PROJECT ADDRESS:

1523 W. 7th St.
Santa Ana, CA 92703

ADDITIONAL STRUCTURAL CALCULATIONS

**RESIDENTIAL PLAN CHECK
 COMMENTS**

ROOF PLAN
WITH FRAMING

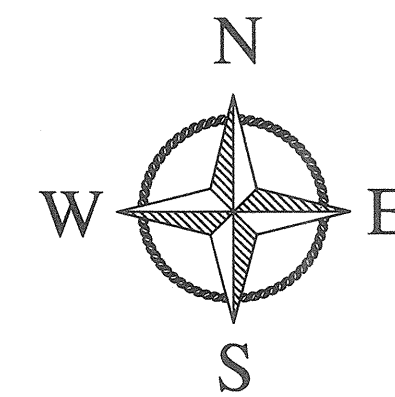
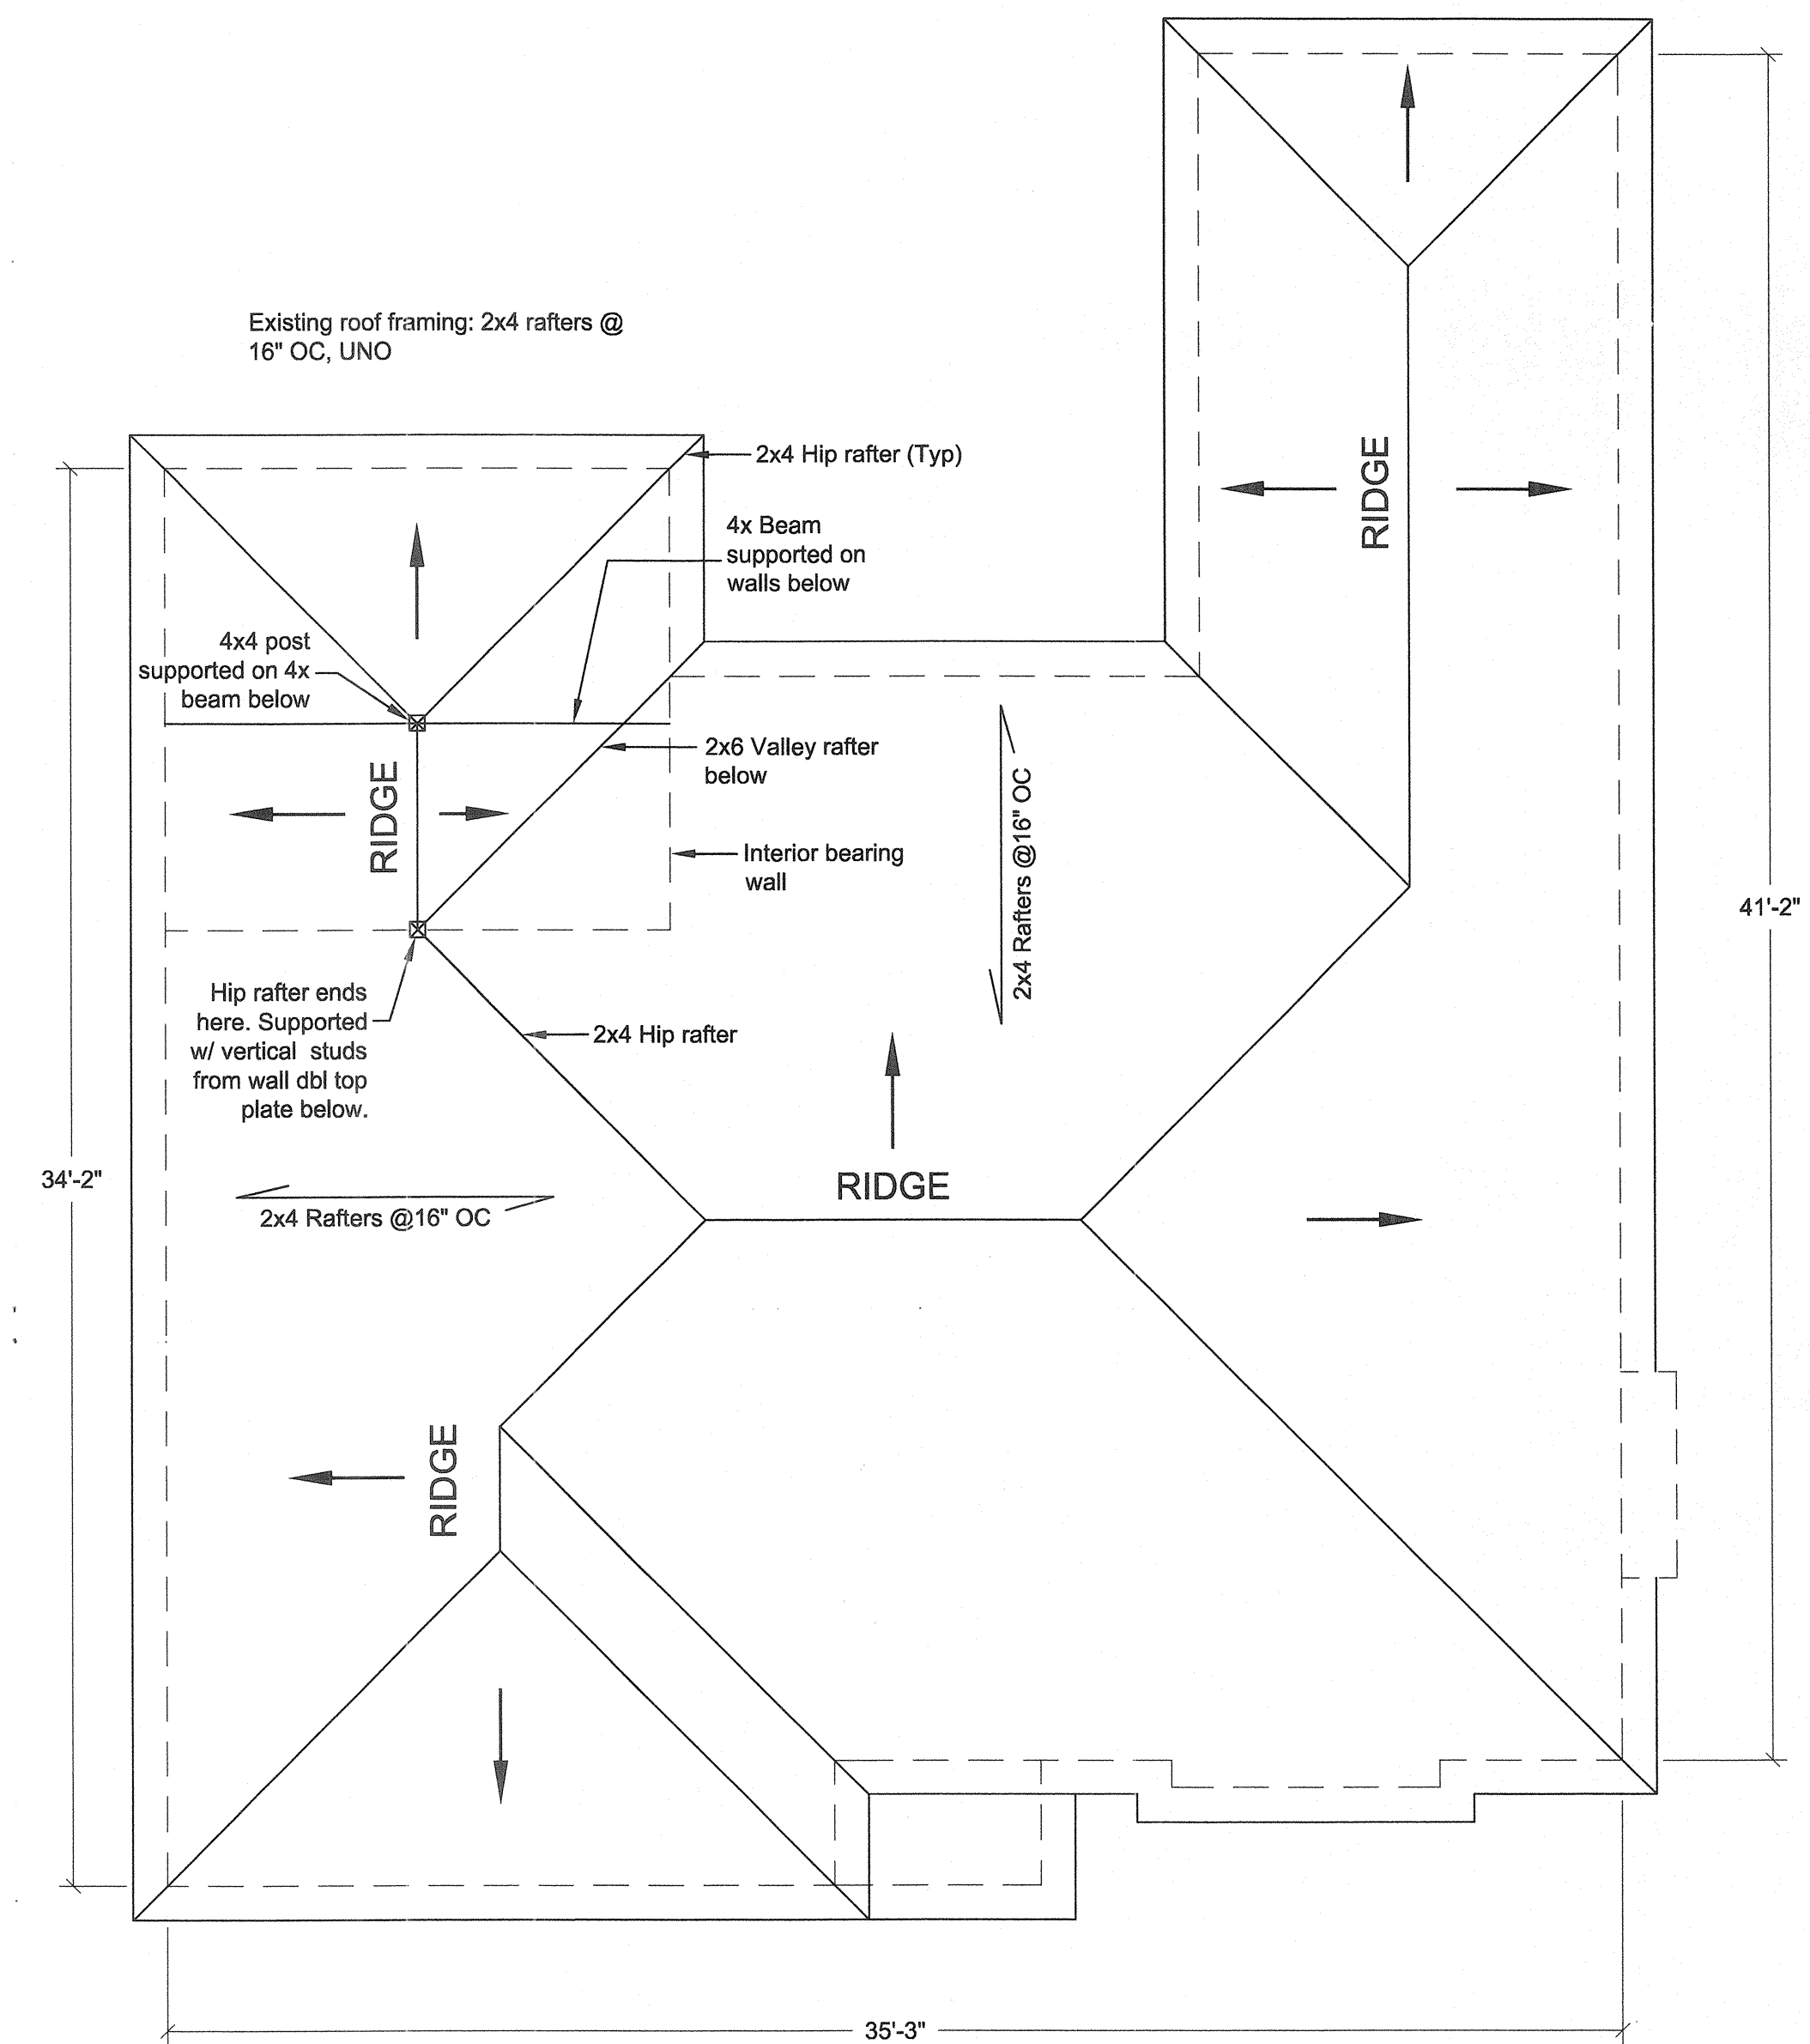
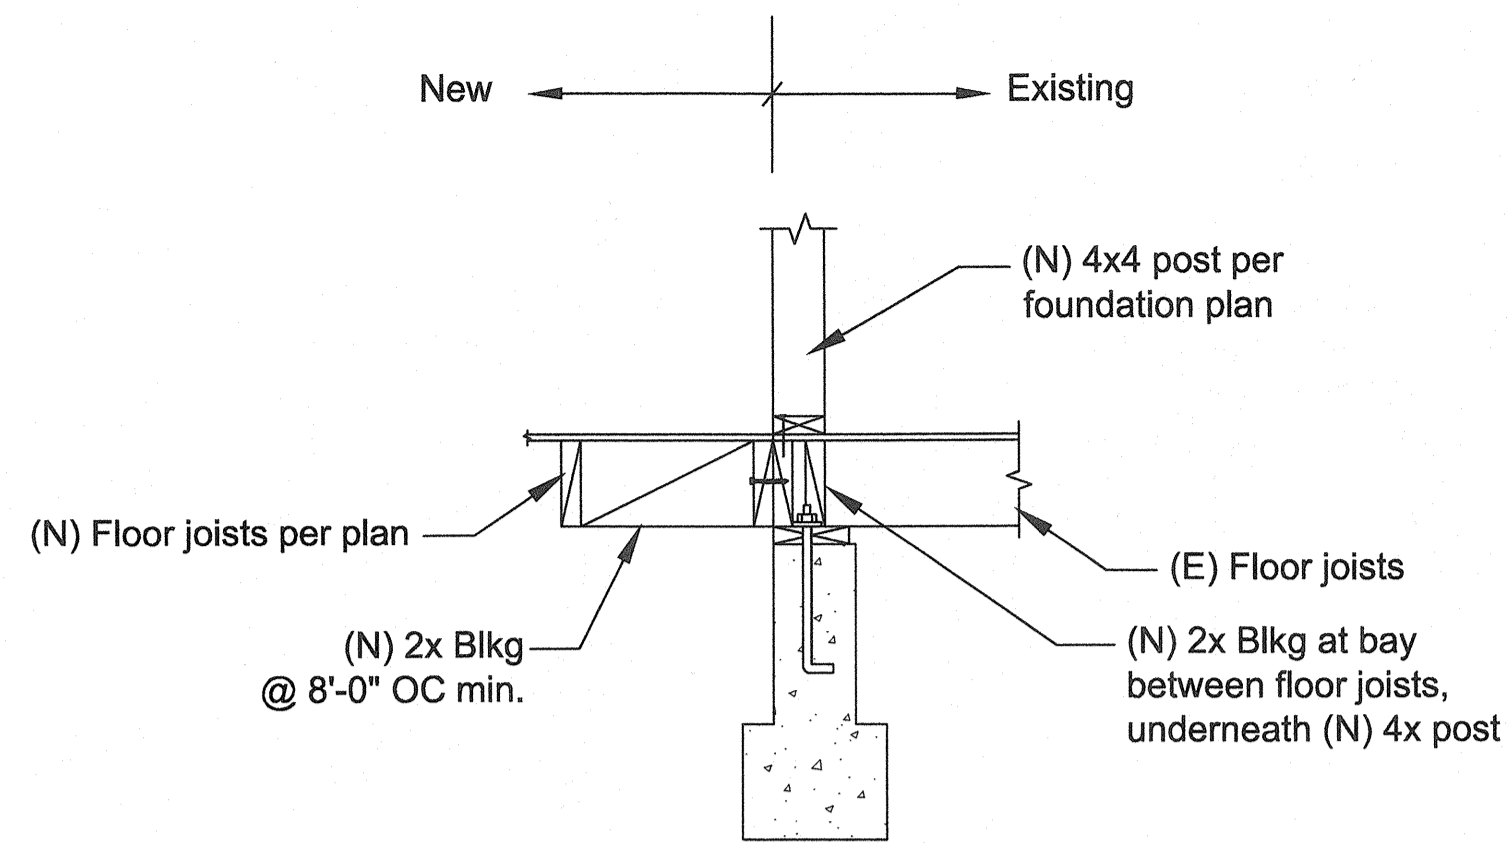
17. Show complete existing framing plan, to include all framing members. — SHEET A-5

18. Show complete new roof framing. SHEET A-5

19. 2x 8 ridge board shall not be used since the ridge is not on the center. (Provide ridge beam.)

34. For plywood roof and floor diaphragm specify thickness, grade, T&G edges, panel span rating, nailing schedule and required blocking and panel layout pattern. ROOF PLAN A-5

DETAIL 7

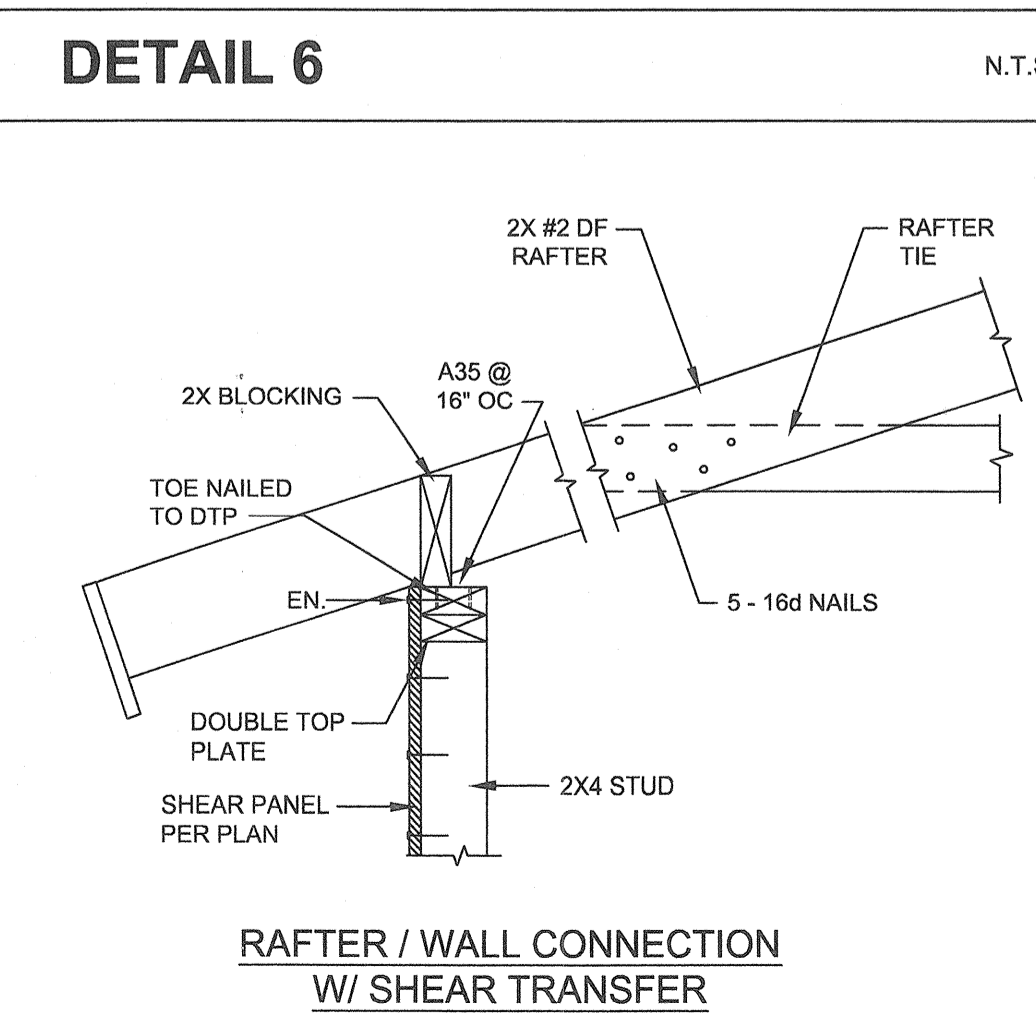
35. Provide a weep screed for stucco at the foundation plate line a minimum of 4 inches above grade and 2 inches above paved areas. CRC R703.6.2.1.

CALLOUT ON ELEV. A-3, DETAIL 7/A-6

DETAIL 5

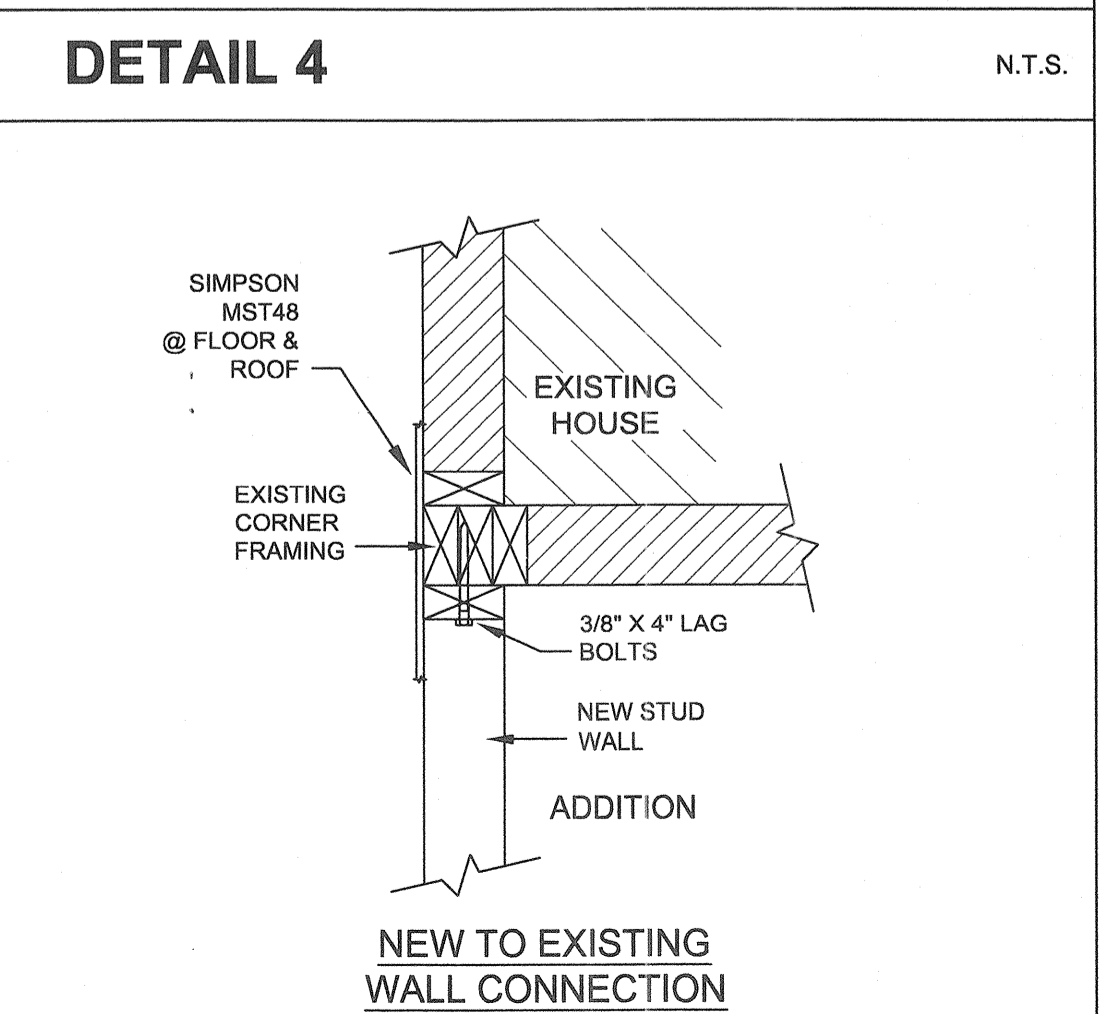
30. Detail the shear transfer connections which transfer lateral forces from horizontal diaphragms through intermediate elements and shear walls to the foundation. (1603) 5/A-6

FOUNDATION SECTION

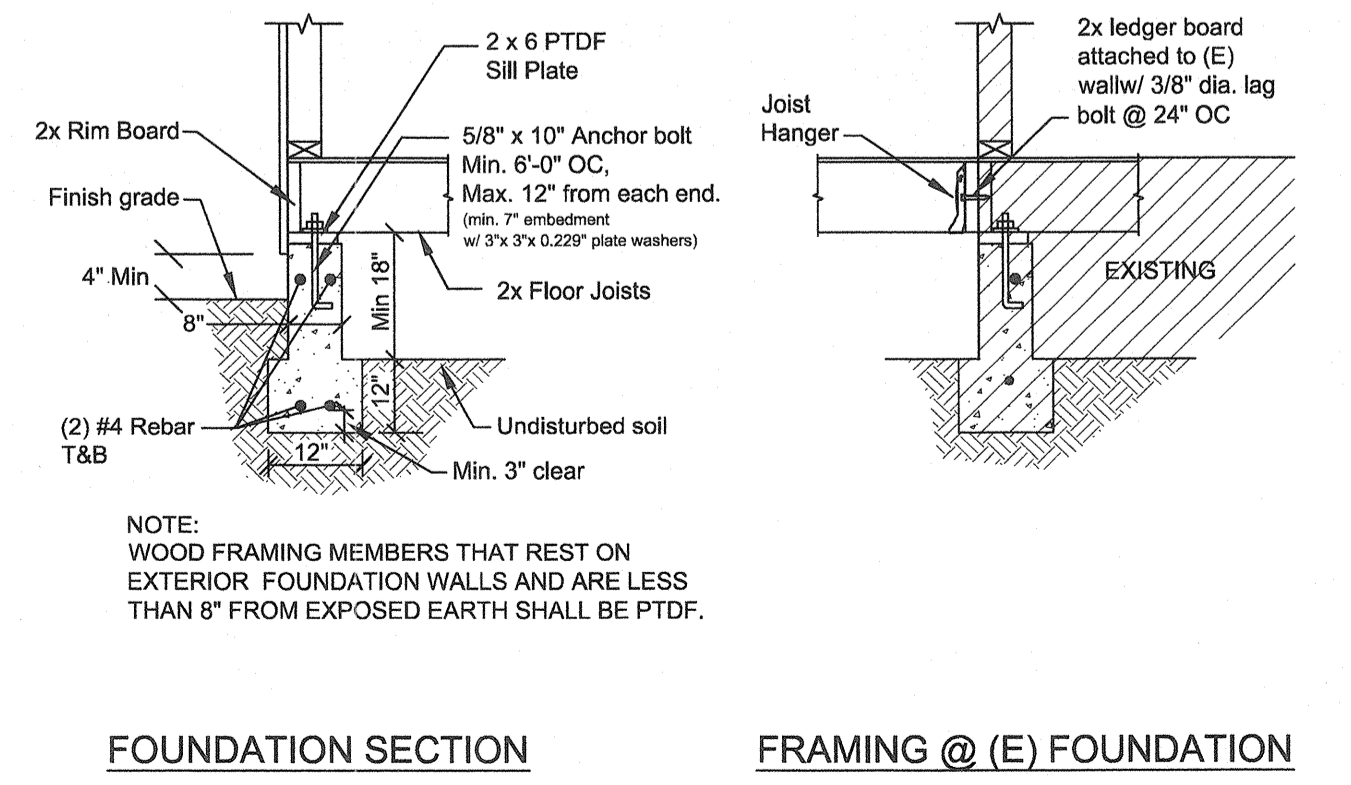
26. Provide a minimum of two No. 4 bars at top and at bottom of continuous footing. 1/A-6

27. Revise footing detail 1/A-6 to show bottom rebar at least 3" CLEAR from ground below. (1907.5)
